RE: **EERA Comments and Recommendations on Scoping Process**
Xcel Energy Alexandria to Big Oaks 345 kV Transmission Project
Docket No. E002, ET2, ET10, E015, E017/TL-23-159
Docket No. E017, ET2, E002, ET10, E015/CN-22-538

ENERGY ENVIRONMENTAL REVIEW AND ANALYSIS COMMENTS AND RECOMMENDATIONS

ALEXANDRIA TO BIG OAKS 345 kV TRANSMISSION PROJECT DOCKET NOS. E017, ET2, E002, ET10, E015/CN-22-538 AND E002, ET2, ET10, E015, E017/TL-23-159

Map 1: Xcel Energy Proposed River Crossing Options

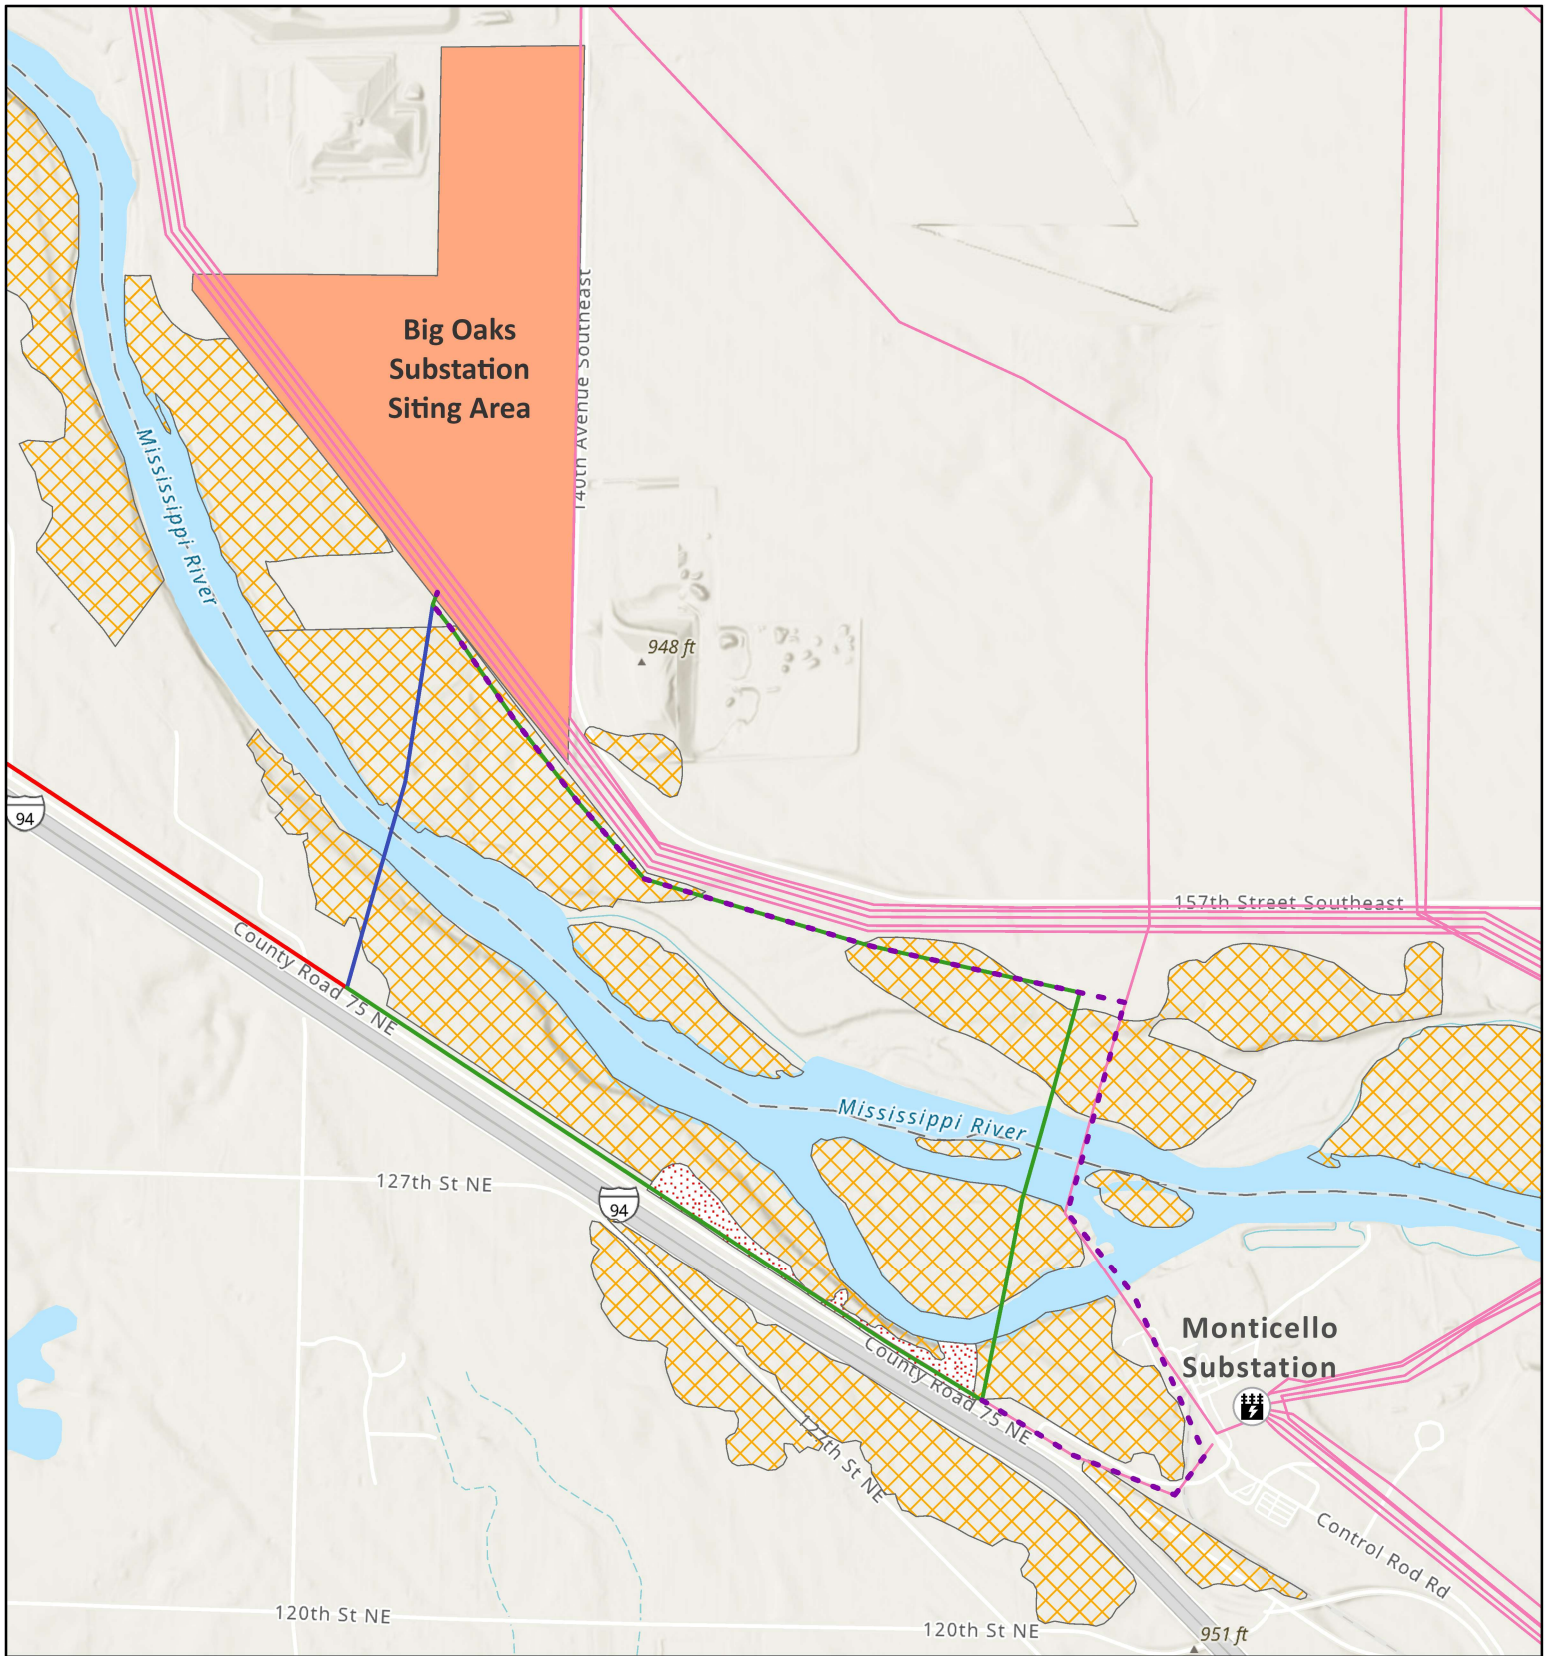
DNR's three proposed alternatives connect to the same endpoints and traverse geography nearby the applicant's proposed Mississippi River Crossings (Map 1). Two of three options would require tree clearing and an additional right-of-way to span the new transmission line across the Mississippi River. One of the options would utilize existing Xcel Energy transmission structures, and thus avoid tree clearing and establishment of an additional right-of-way.

DNR states in their scoping comments that all three of their alternatives would have less human and environmental impacts than Xcel Energy's proposed Mississippi River Crossing options. DNR believes that Xcel Energy's crossing options would "further fragment the habitat in this area and would place two pole structures within the floodway of the Mississippi River, posing ongoing challenges for pole stability."²⁵

Map 2: DNR Alternative 1

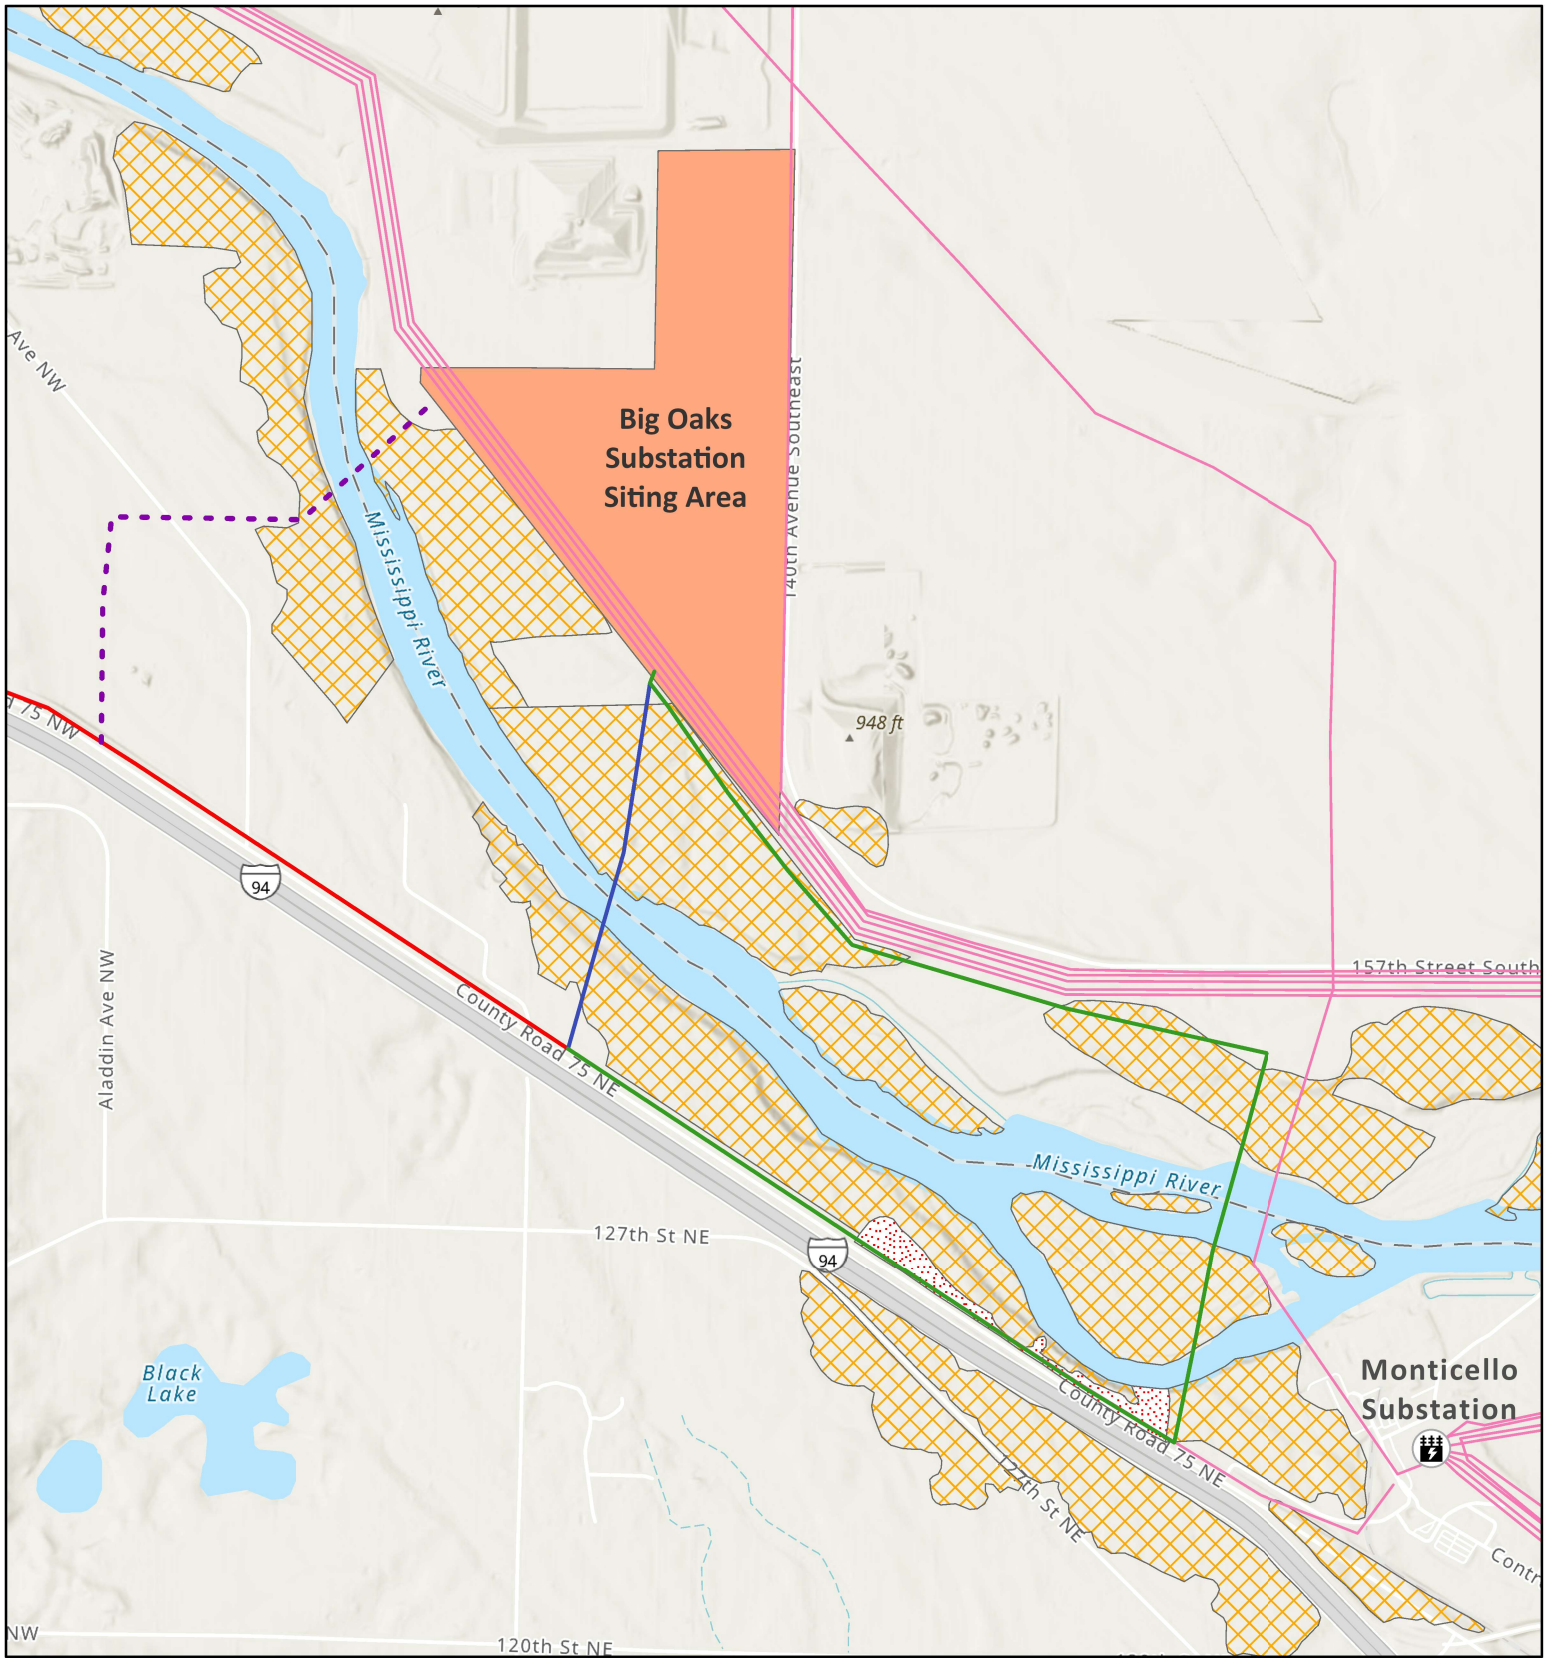
DNR Alternative 1 is DNR's preferred route for crossing the Mississippi River. This option would rebuild an existing Xcel Energy 115 kV transmission line to accommodate the project's new 345 kV line (Map 2). This option would create a double-circuit 345/115 kV crossing of the river. An existing Xcel Energy 345 kV transmission line runs along Interstate 94 until it enters and terminates at Monticello Substation. An existing 115 kV line, which would have to be rebuilt to accommodate the project's new 345 kV line, exits Monticello Substation northwest to cross the Mississippi River, and ultimately routes near the north end of the Big Oaks Substation siting area. DNR Alternative 1 would route the new 345 kV line adjacent to the Monticello Substation and would connect to the existing 115 kV line west of the substation. Using existing infrastructure for the project's transmission line would combine new right-of-way with existing right-of-way to the greatest extent possible.

Impacts would be reduced by decreasing tree clearing and vegetation disturbance in sensitive ecological areas that contains MBS Sites of High Biodiversity Significance, DNR Native Plant Communities, and a wild and scenic river district. Rebuilding existing 115 kV infrastructure to accommodate the project's 345 kV line would result in increased costs compared to the project.

Map 3: DNR Alternative 2

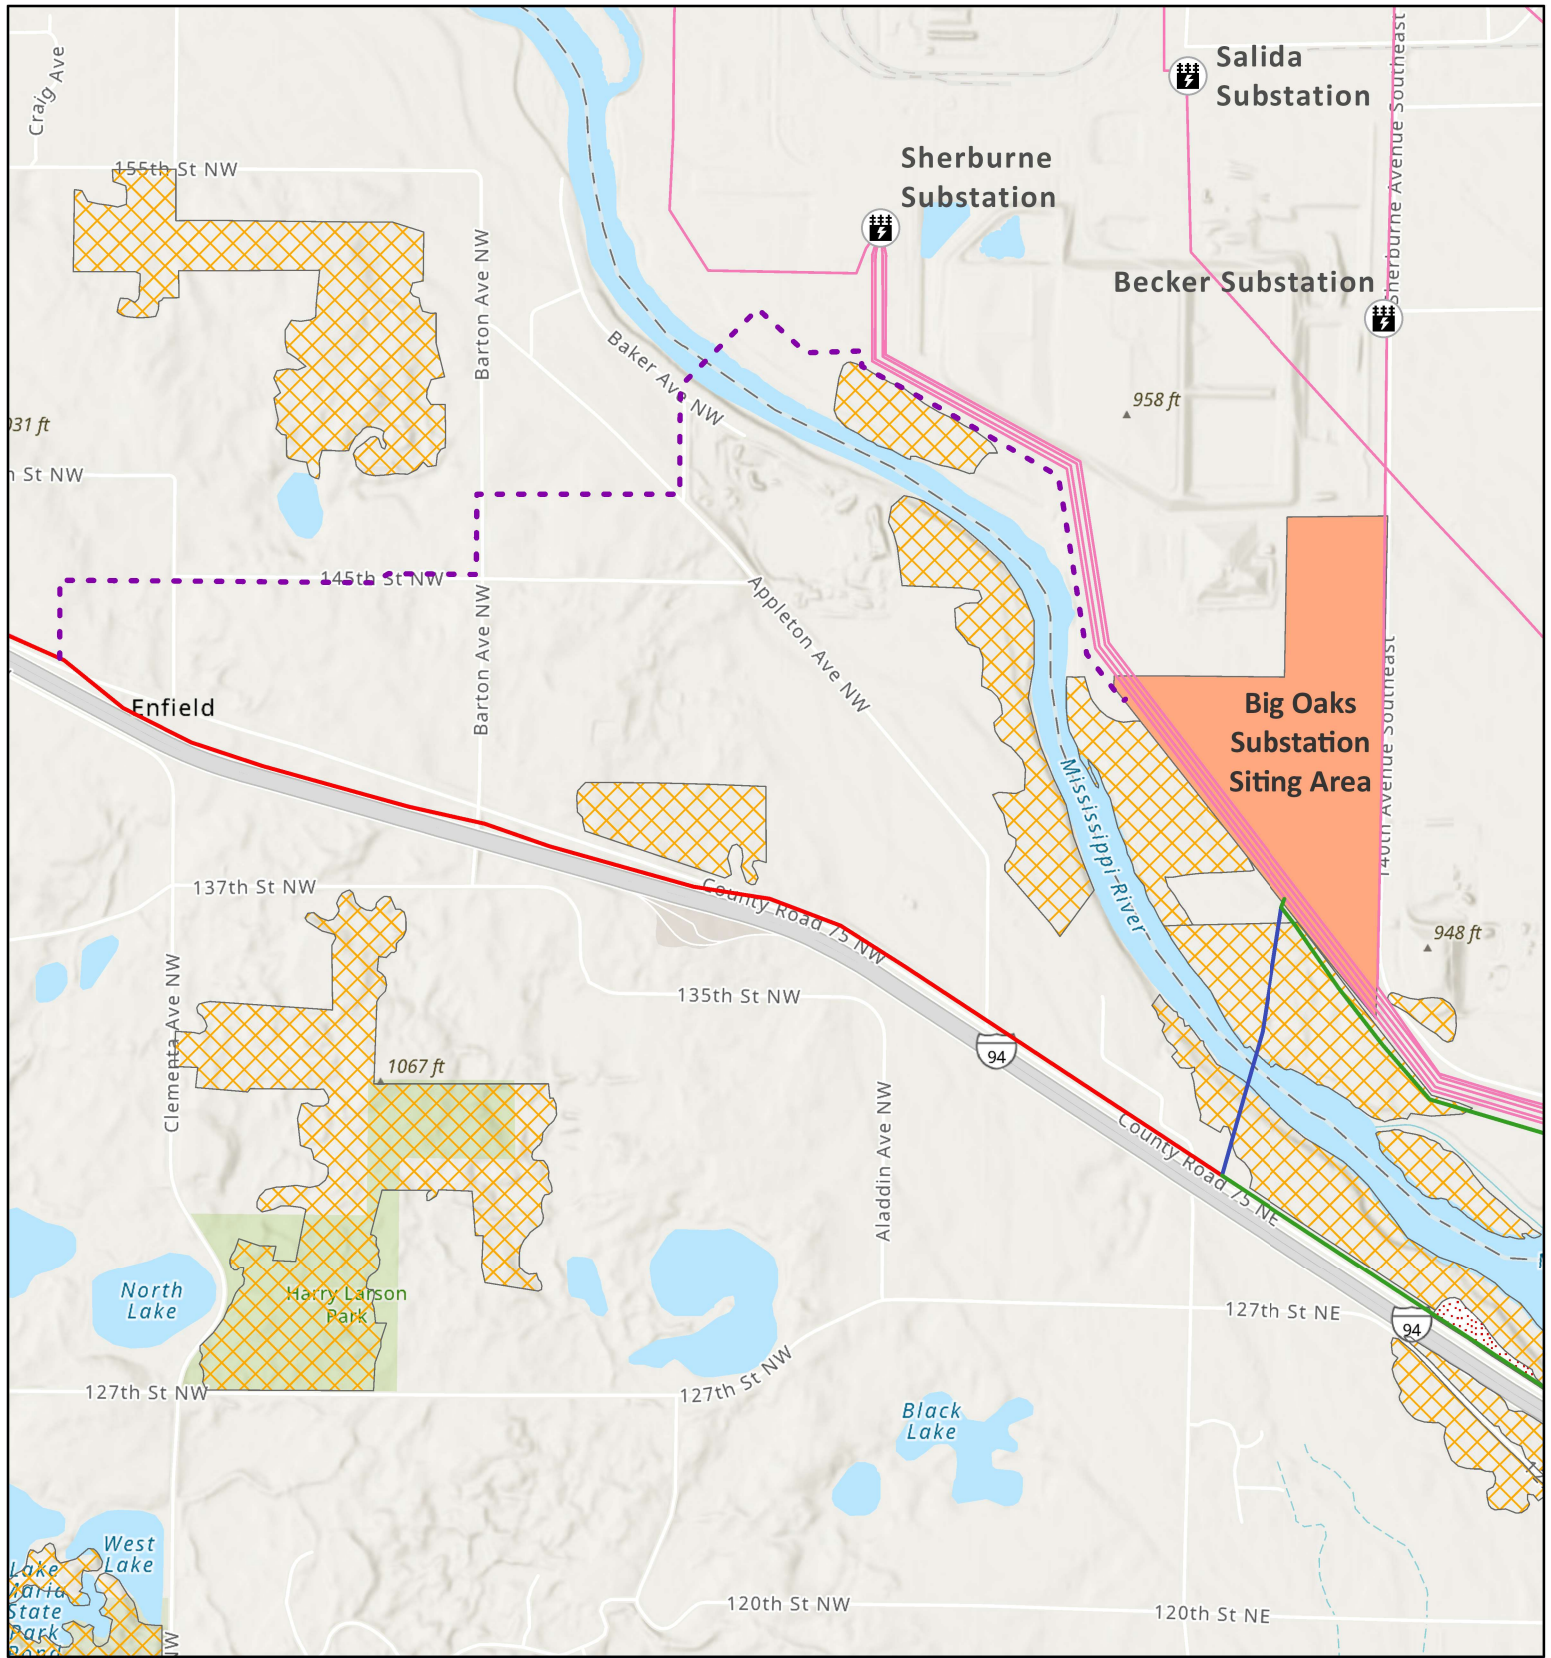
DNR Alternative 2 would cross at a narrower point of the Mississippi River northwest of Xcel Energy's West Crossing Option (Map 3).

Impacts would be reduced to MBS Sites of Biodiversity Significance and DNR Native Plant Communities by spanning the river entirely, thus avoiding impacts to the bank and floodway while also improving pole structure stability. This route would still disturb sensitive ecological areas and introduce an additional river crossing within a wild and scenic river district.

A suggested 1,500-foot right-of-way would provide flexibility to avoid impacts from placing infrastructure near residences and agricultural fields with center pivot irrigation. Xcel Energy states that DNR Alternative 2 would require acquisition of new right-of-way from private landowners as the project would be placed closer to residences, whereas Xcel Energy's proposed crossings are entirely on Xcel Energy owned land and have no residences within 500 feet. DNR Alternative 2 is within 500 feet of two residences and within 335 feet of the nearest residence. Lastly, new easements would be required from two landowners of agricultural land.

Map 4: DNR Alternative 3

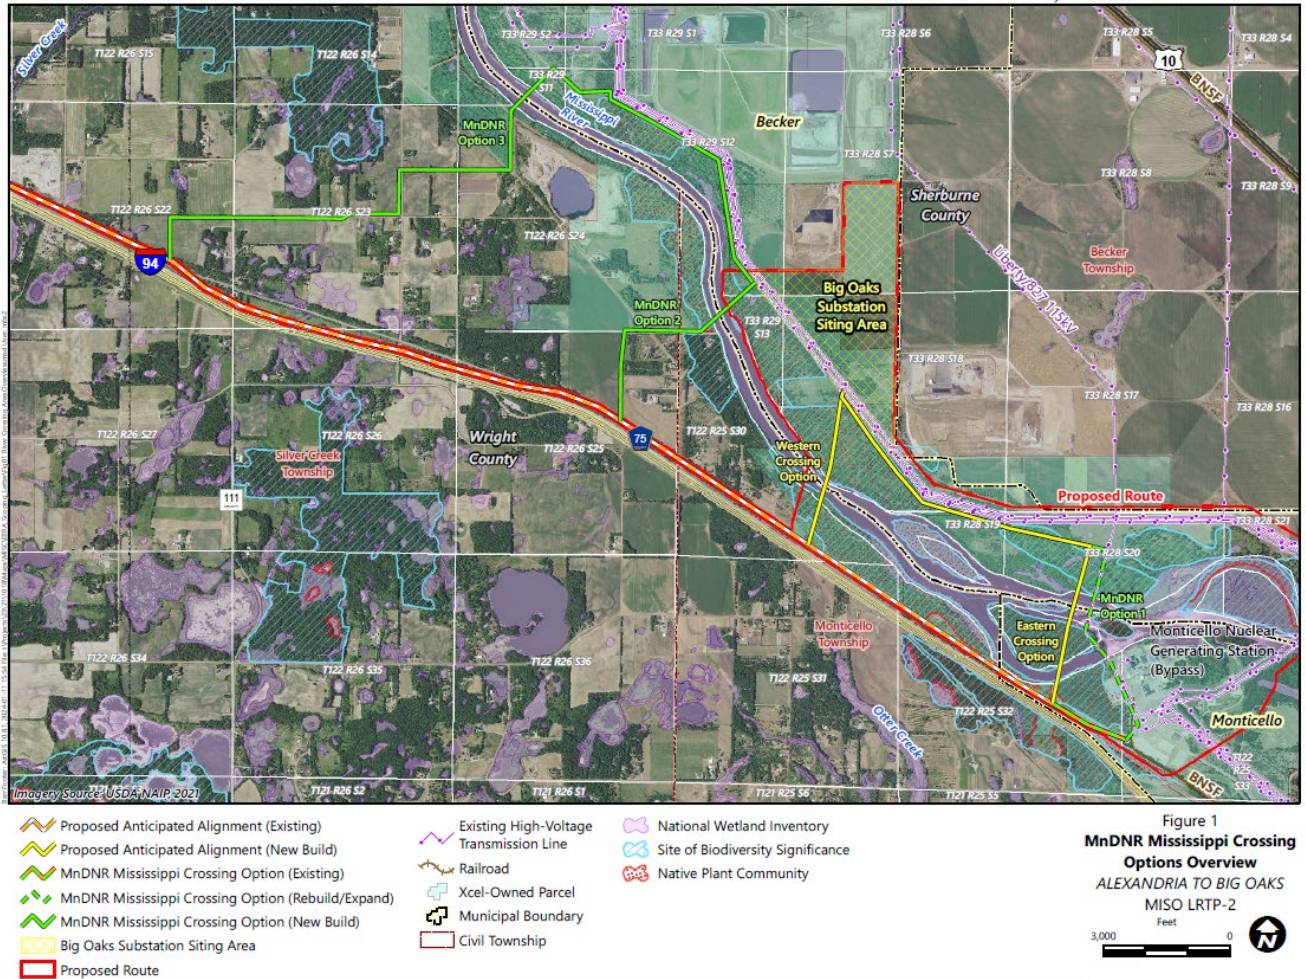
DNR Alternative 3 deviates from the proposed route further west along Interstate 94's existing transmission line infrastructure, then would route north and east by using existing roads and natural boundaries near agricultural fields as much as possible. The line would ultimately cross the Mississippi River northwest of the proposed Big Oaks Substation, and interconnect into or along existing Xcel Energy 345 kV transmission line infrastructure near Sherburne County Substation (Map 4).

Impacts would be reduced by entirely avoiding sensitive MBS Sites of Biodiversity Significance and DNR Native Plant Communities. This crossing is at a narrow point that can likely be spanned, thus avoids disturbance to river bluffs and minimizes pole structure placement within a floodway. This route would still introduce an additional river crossing within a wild and scenic river district.

A suggested 1,500-foot right-of-way would provide flexibility to avoid impacts from placing infrastructure near residences and agricultural fields with center pivot irrigation. Xcel Energy states that DNR Alternative 3 would require acquisition of new right-of-way from private landowners as the project would be placed closer to residences, whereas Xcel Energy’s proposed crossings are entirely on Xcel Energy owned land and have no residences within 500 feet. DNR Alternative 3 is within 500 feet of seven residences and within 118 feet of the nearest residence. Lastly, new easements would be required from eight landowners of agricultural land.

DNR Alternative 3 is 3.9 miles long while Xcel Energy’s Western and Eastern Crossing Options are 0.7 and 2.1 miles long, respectively. This increased length would require more foundations and structures, resulting in increased costs compared to the project.
